MISSISSIPPI RIVER-GULF OUTLET, LOUISIANA

GENERAL DESIGN MEMORANDUM NO. 2
SUPPLEMENT NO. 4
FORESHORE PROTECTION

SUBJECT: Mississippi River - Gulf Outlet, Louisiana, General Design
Memorandum No. 2, Supplement No. 4, Foreshore Protection

MISSISSIPPI RIVER, BATON ROUGE TO GULF OF MEXICO
 MISSISSIPPI RIVER-GULF OUTLET
 GENERAL DESIGN MEMO. NO. 2
 SUPPLEMENT NO. 4

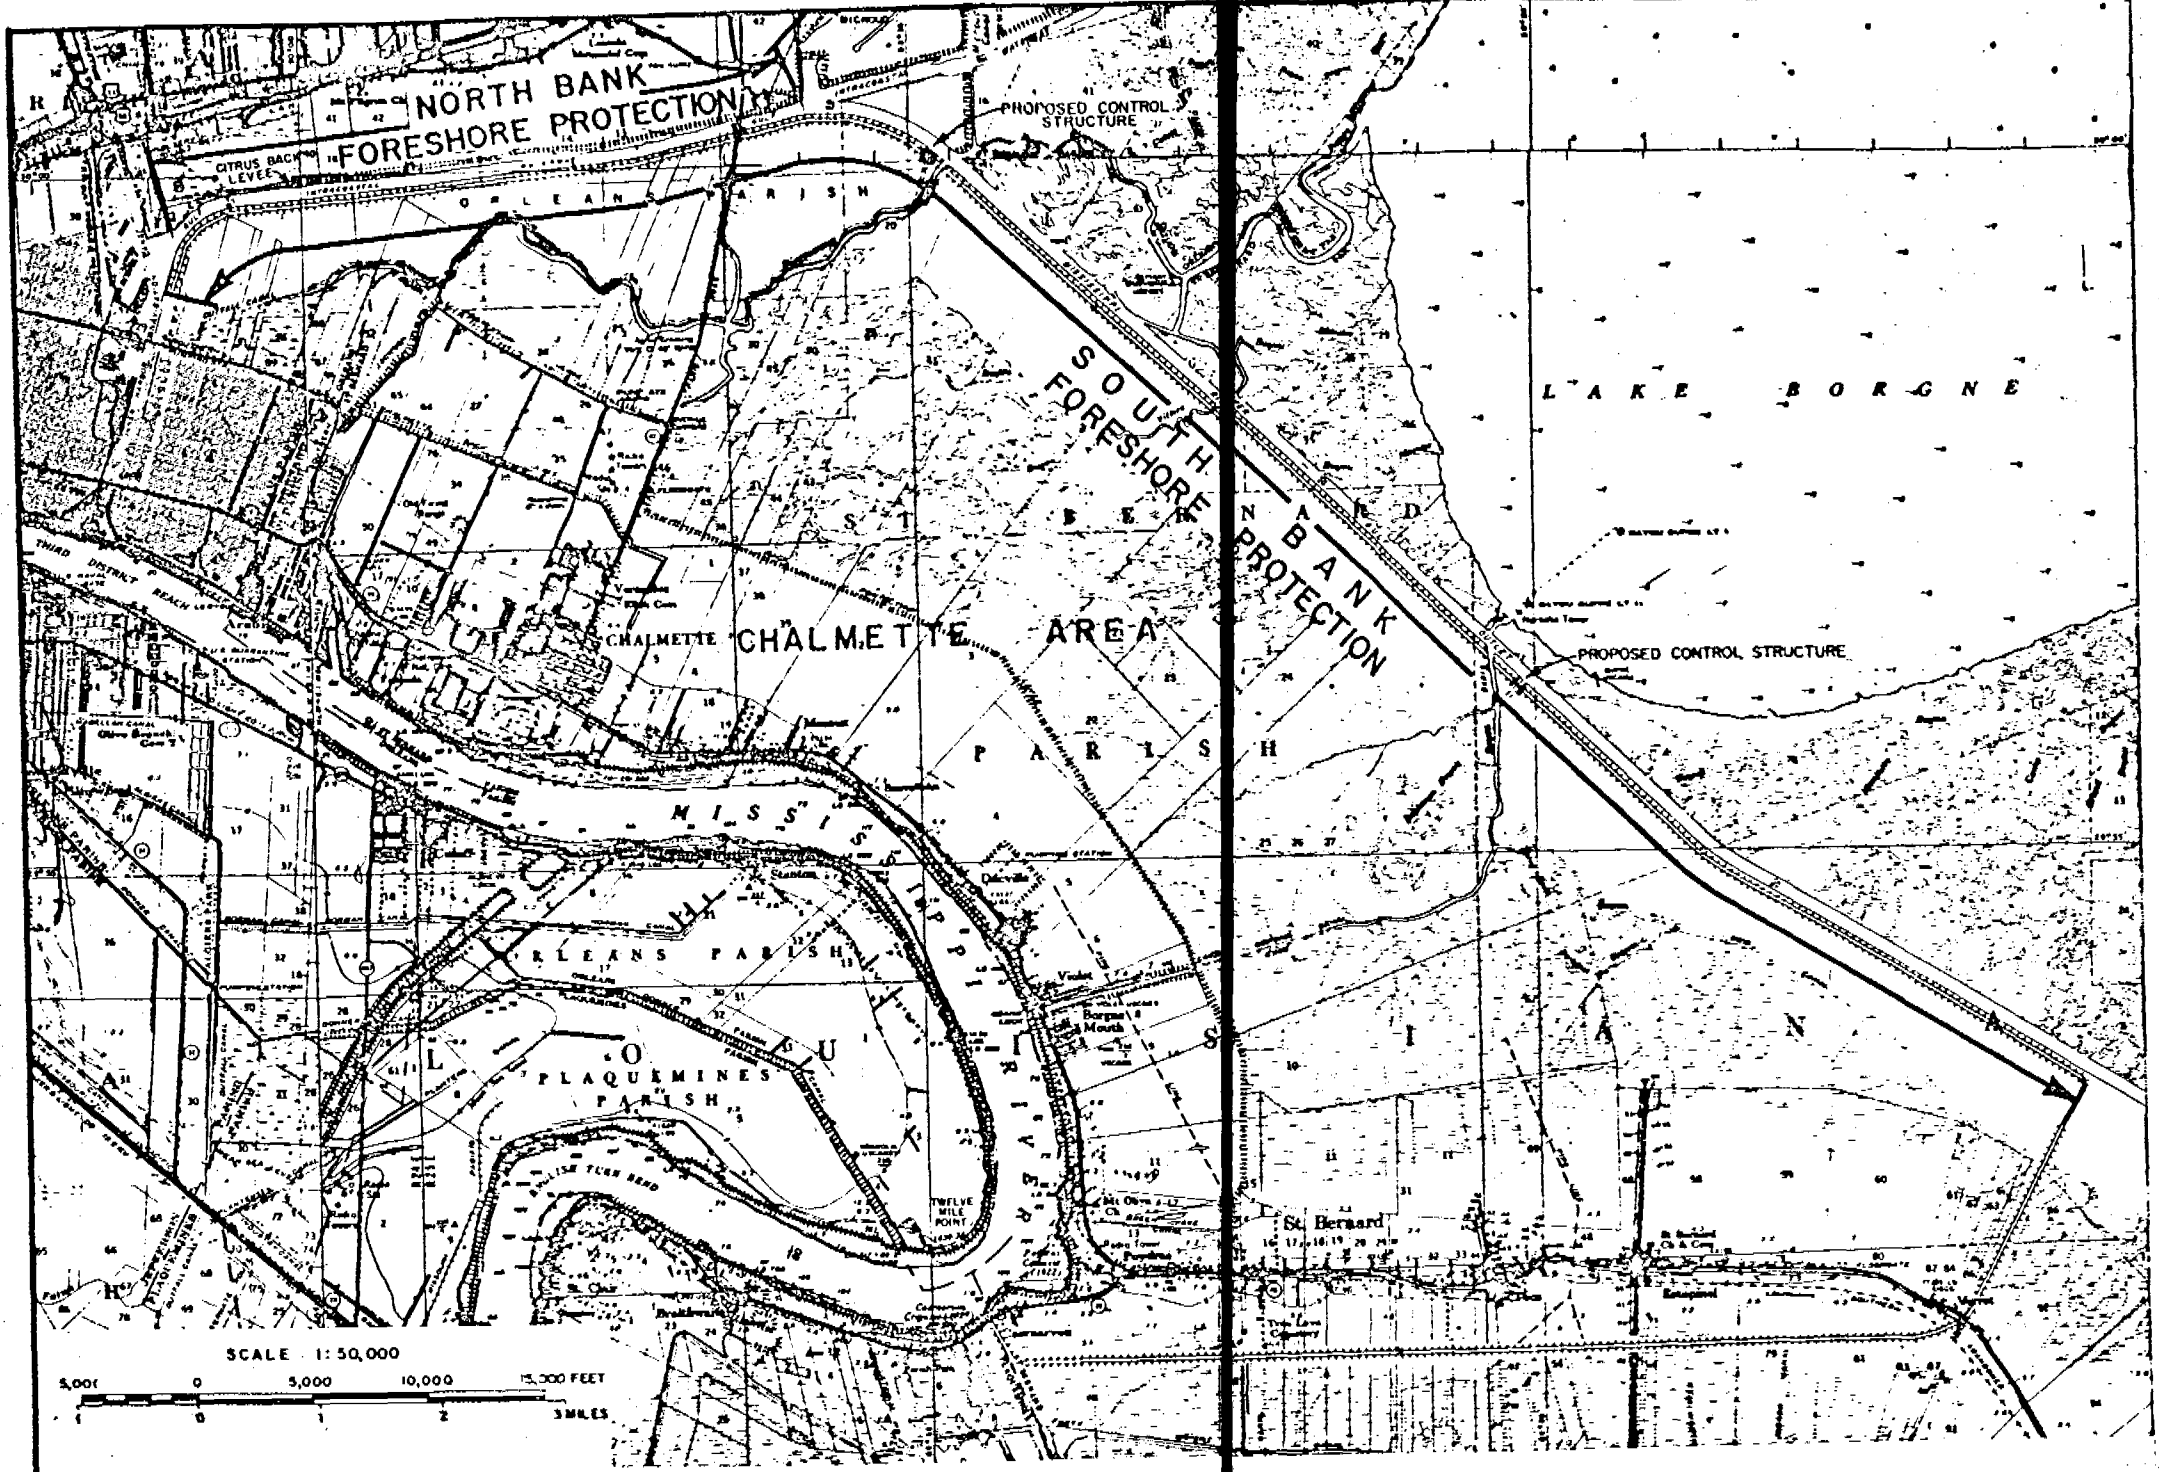
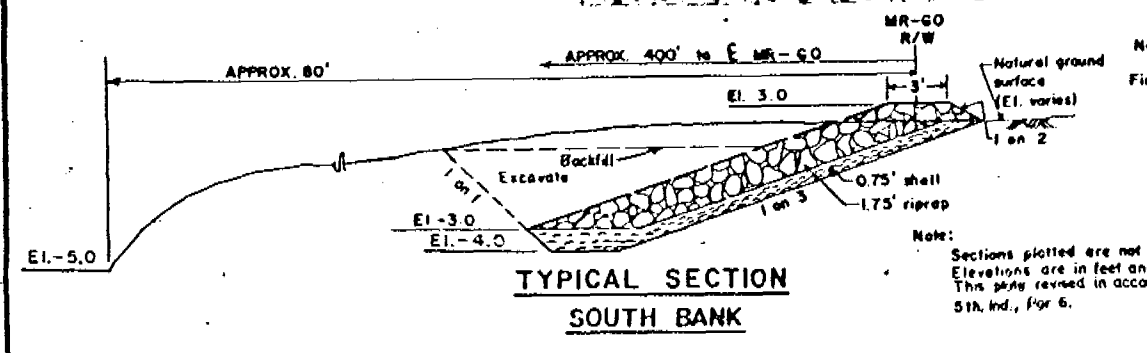
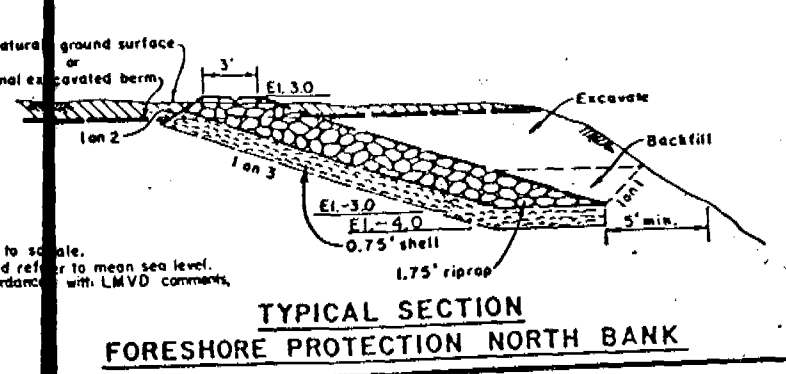
6. Plate 2. The shell blanket should be placed beneath the base of the protection dikes as indicated in red to provide a proper bedding for the stone.

e. Par. 6. The shell blanket will be placed as shown on inclosed revised plate 2 (incl 5) and will increase the quantity of shell required on the north and south shores by 6,000 and 21,450 cubic yards, respectively. Pages 3 and 4 of the subject supplement have been revised (incl 6) to reflect the additional cost.

Note: Sections plotted are not to scale. Elevations are in feet and refer to mean sea level. This plate revised in accordance with LMVD comments, 51A, Ind., for 6.
